**TITLE:** **PRELIMINARY PLAT NO. 02023, EDENTON WOODS**, requested by Engineering Design Consultants on behalf of Caseyco, for 46 lots for residential development and 5 outlots, with associated waiver requests, on property generally located northeast of the intersection of Ashbrook Drive and Highway 2 (adjacent to the west of the former Pine Lake S.I.D.).

Re: Preliminary Plat No. 02023  
EDENTON WOODS

## LINCOLN CITY/LANCASTER COUNTY PLANNING STAFF REPORT

**To:** Brian Will, Planning Department  
**From:** Chad Blahak, Public Works and Utilities  
**Subject:** Edenton Woods Preliminary Plat and Special Permit  
**Date:** 6/27/03  
**cc:** Randy Hoskins

# PRELIMINARY PLAT & C.U.P.

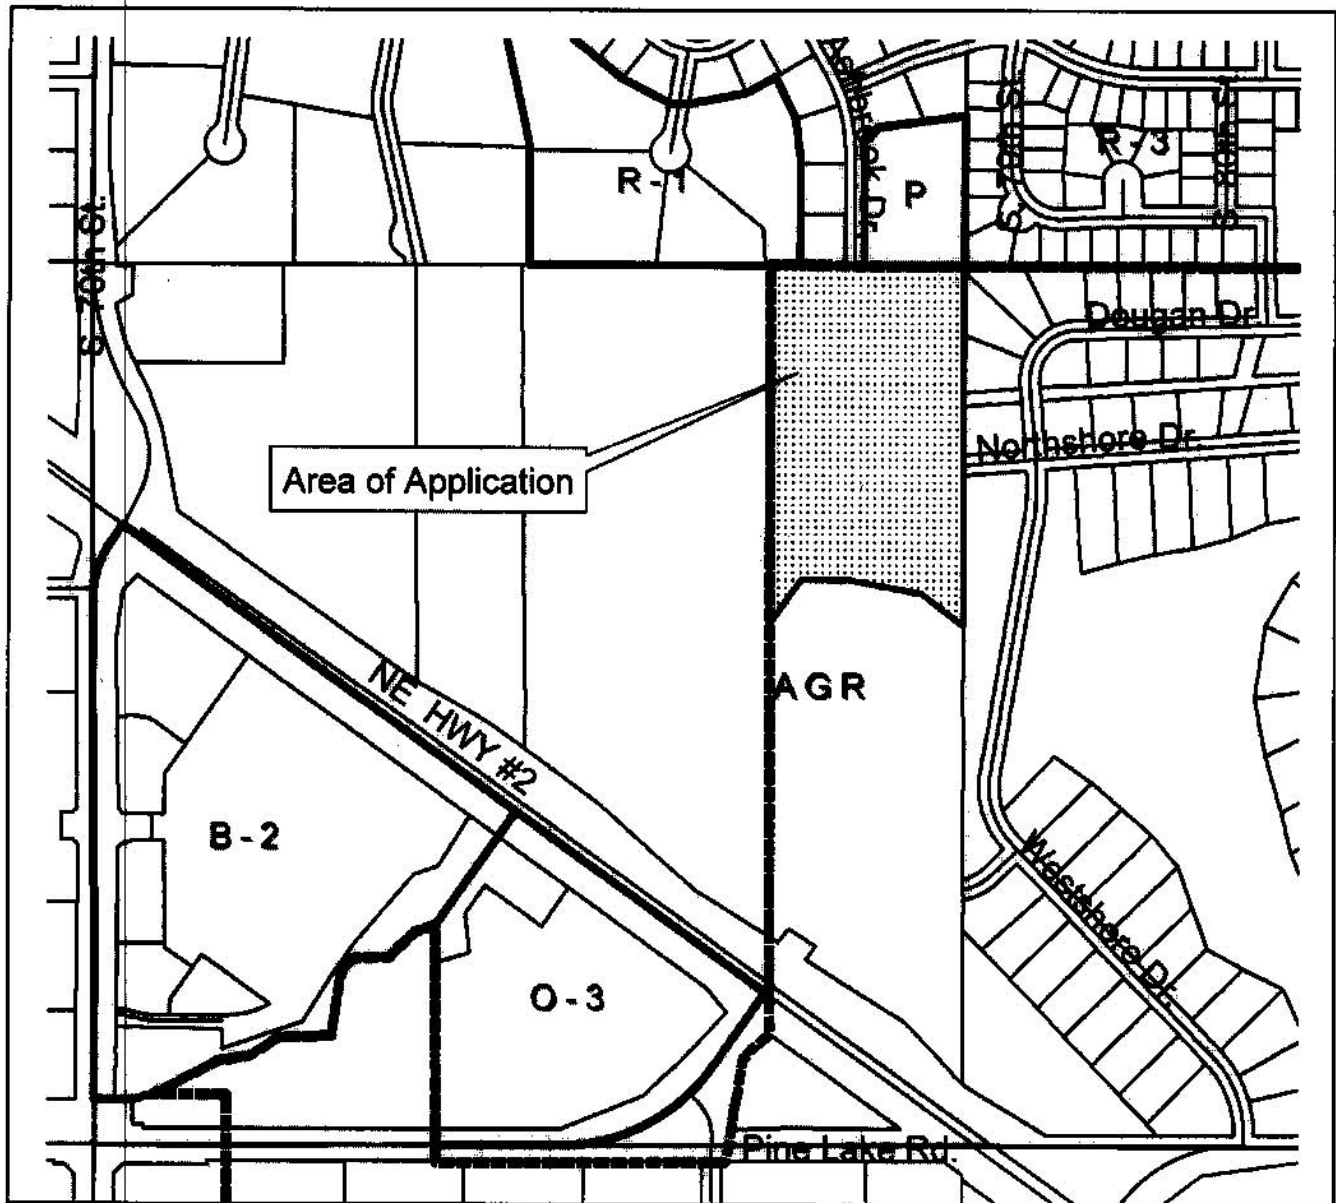
Condition #1.1.5 requires that Bo Creek Bay and Bo Creek Court (the private roadway on the east edge) end in a 30' radius cul-de-sac. Again, Hunzeker pointed out that this is not a design standard

With regard to Condition #1.1.5 and the 30' radius, Brian Will of Planning staff indicated that this requirement is a means to provide some method of turnaround for vehicles, including trafficking cars as well as emergency vehicles. Chad Blahak of Public Works further responded that there is not a specific design standard that references private roadways; however, the standards for public roadways that have this type of turnaround specifically state that no direct access will be taken from this type of hammerhead turnaround. Staff would prefer the 30' turnaround.

- The turnarounds in Bo Creek Court and Bo Creek Bay do not meet subdivision requirements. It appears that 30' radius turnarounds would fit at both ends. The plans should be revised to show 30' radius turnarounds. A barricaded dead-end for a permanent turnaround is unsatisfactory.

- According to the culvert calculations shown on the plans, the 50yr and the 100yr storms will flood the lots north of North Shore Drive. Also, the water elevation at the outlet of the culvert shown indicates that lots south of North Shore Drive along the channel will also be flooded. Public Works recommends that the lots be raised or reduced in depth to eliminate the flooding of any lot for any storm less than or equal to the 100yr storm.

- The areas designated as tree removal do not match the proposed grading contours. It appears more trees will need to be removed according to the contours. The contours need to be revised or the tree removal hatch needs to be adjusted accordingly.

- 1.1.4 The dam spillway delineated on the plat.
    - 1.1.5 Adequate turn-arounds with a minimum 30' radius at the ends of both Bo Creek Bay and Bo Creek Court to the satisfaction of Public Works & Utilities. (\*\*Per Planning Commission: 7/09/03)
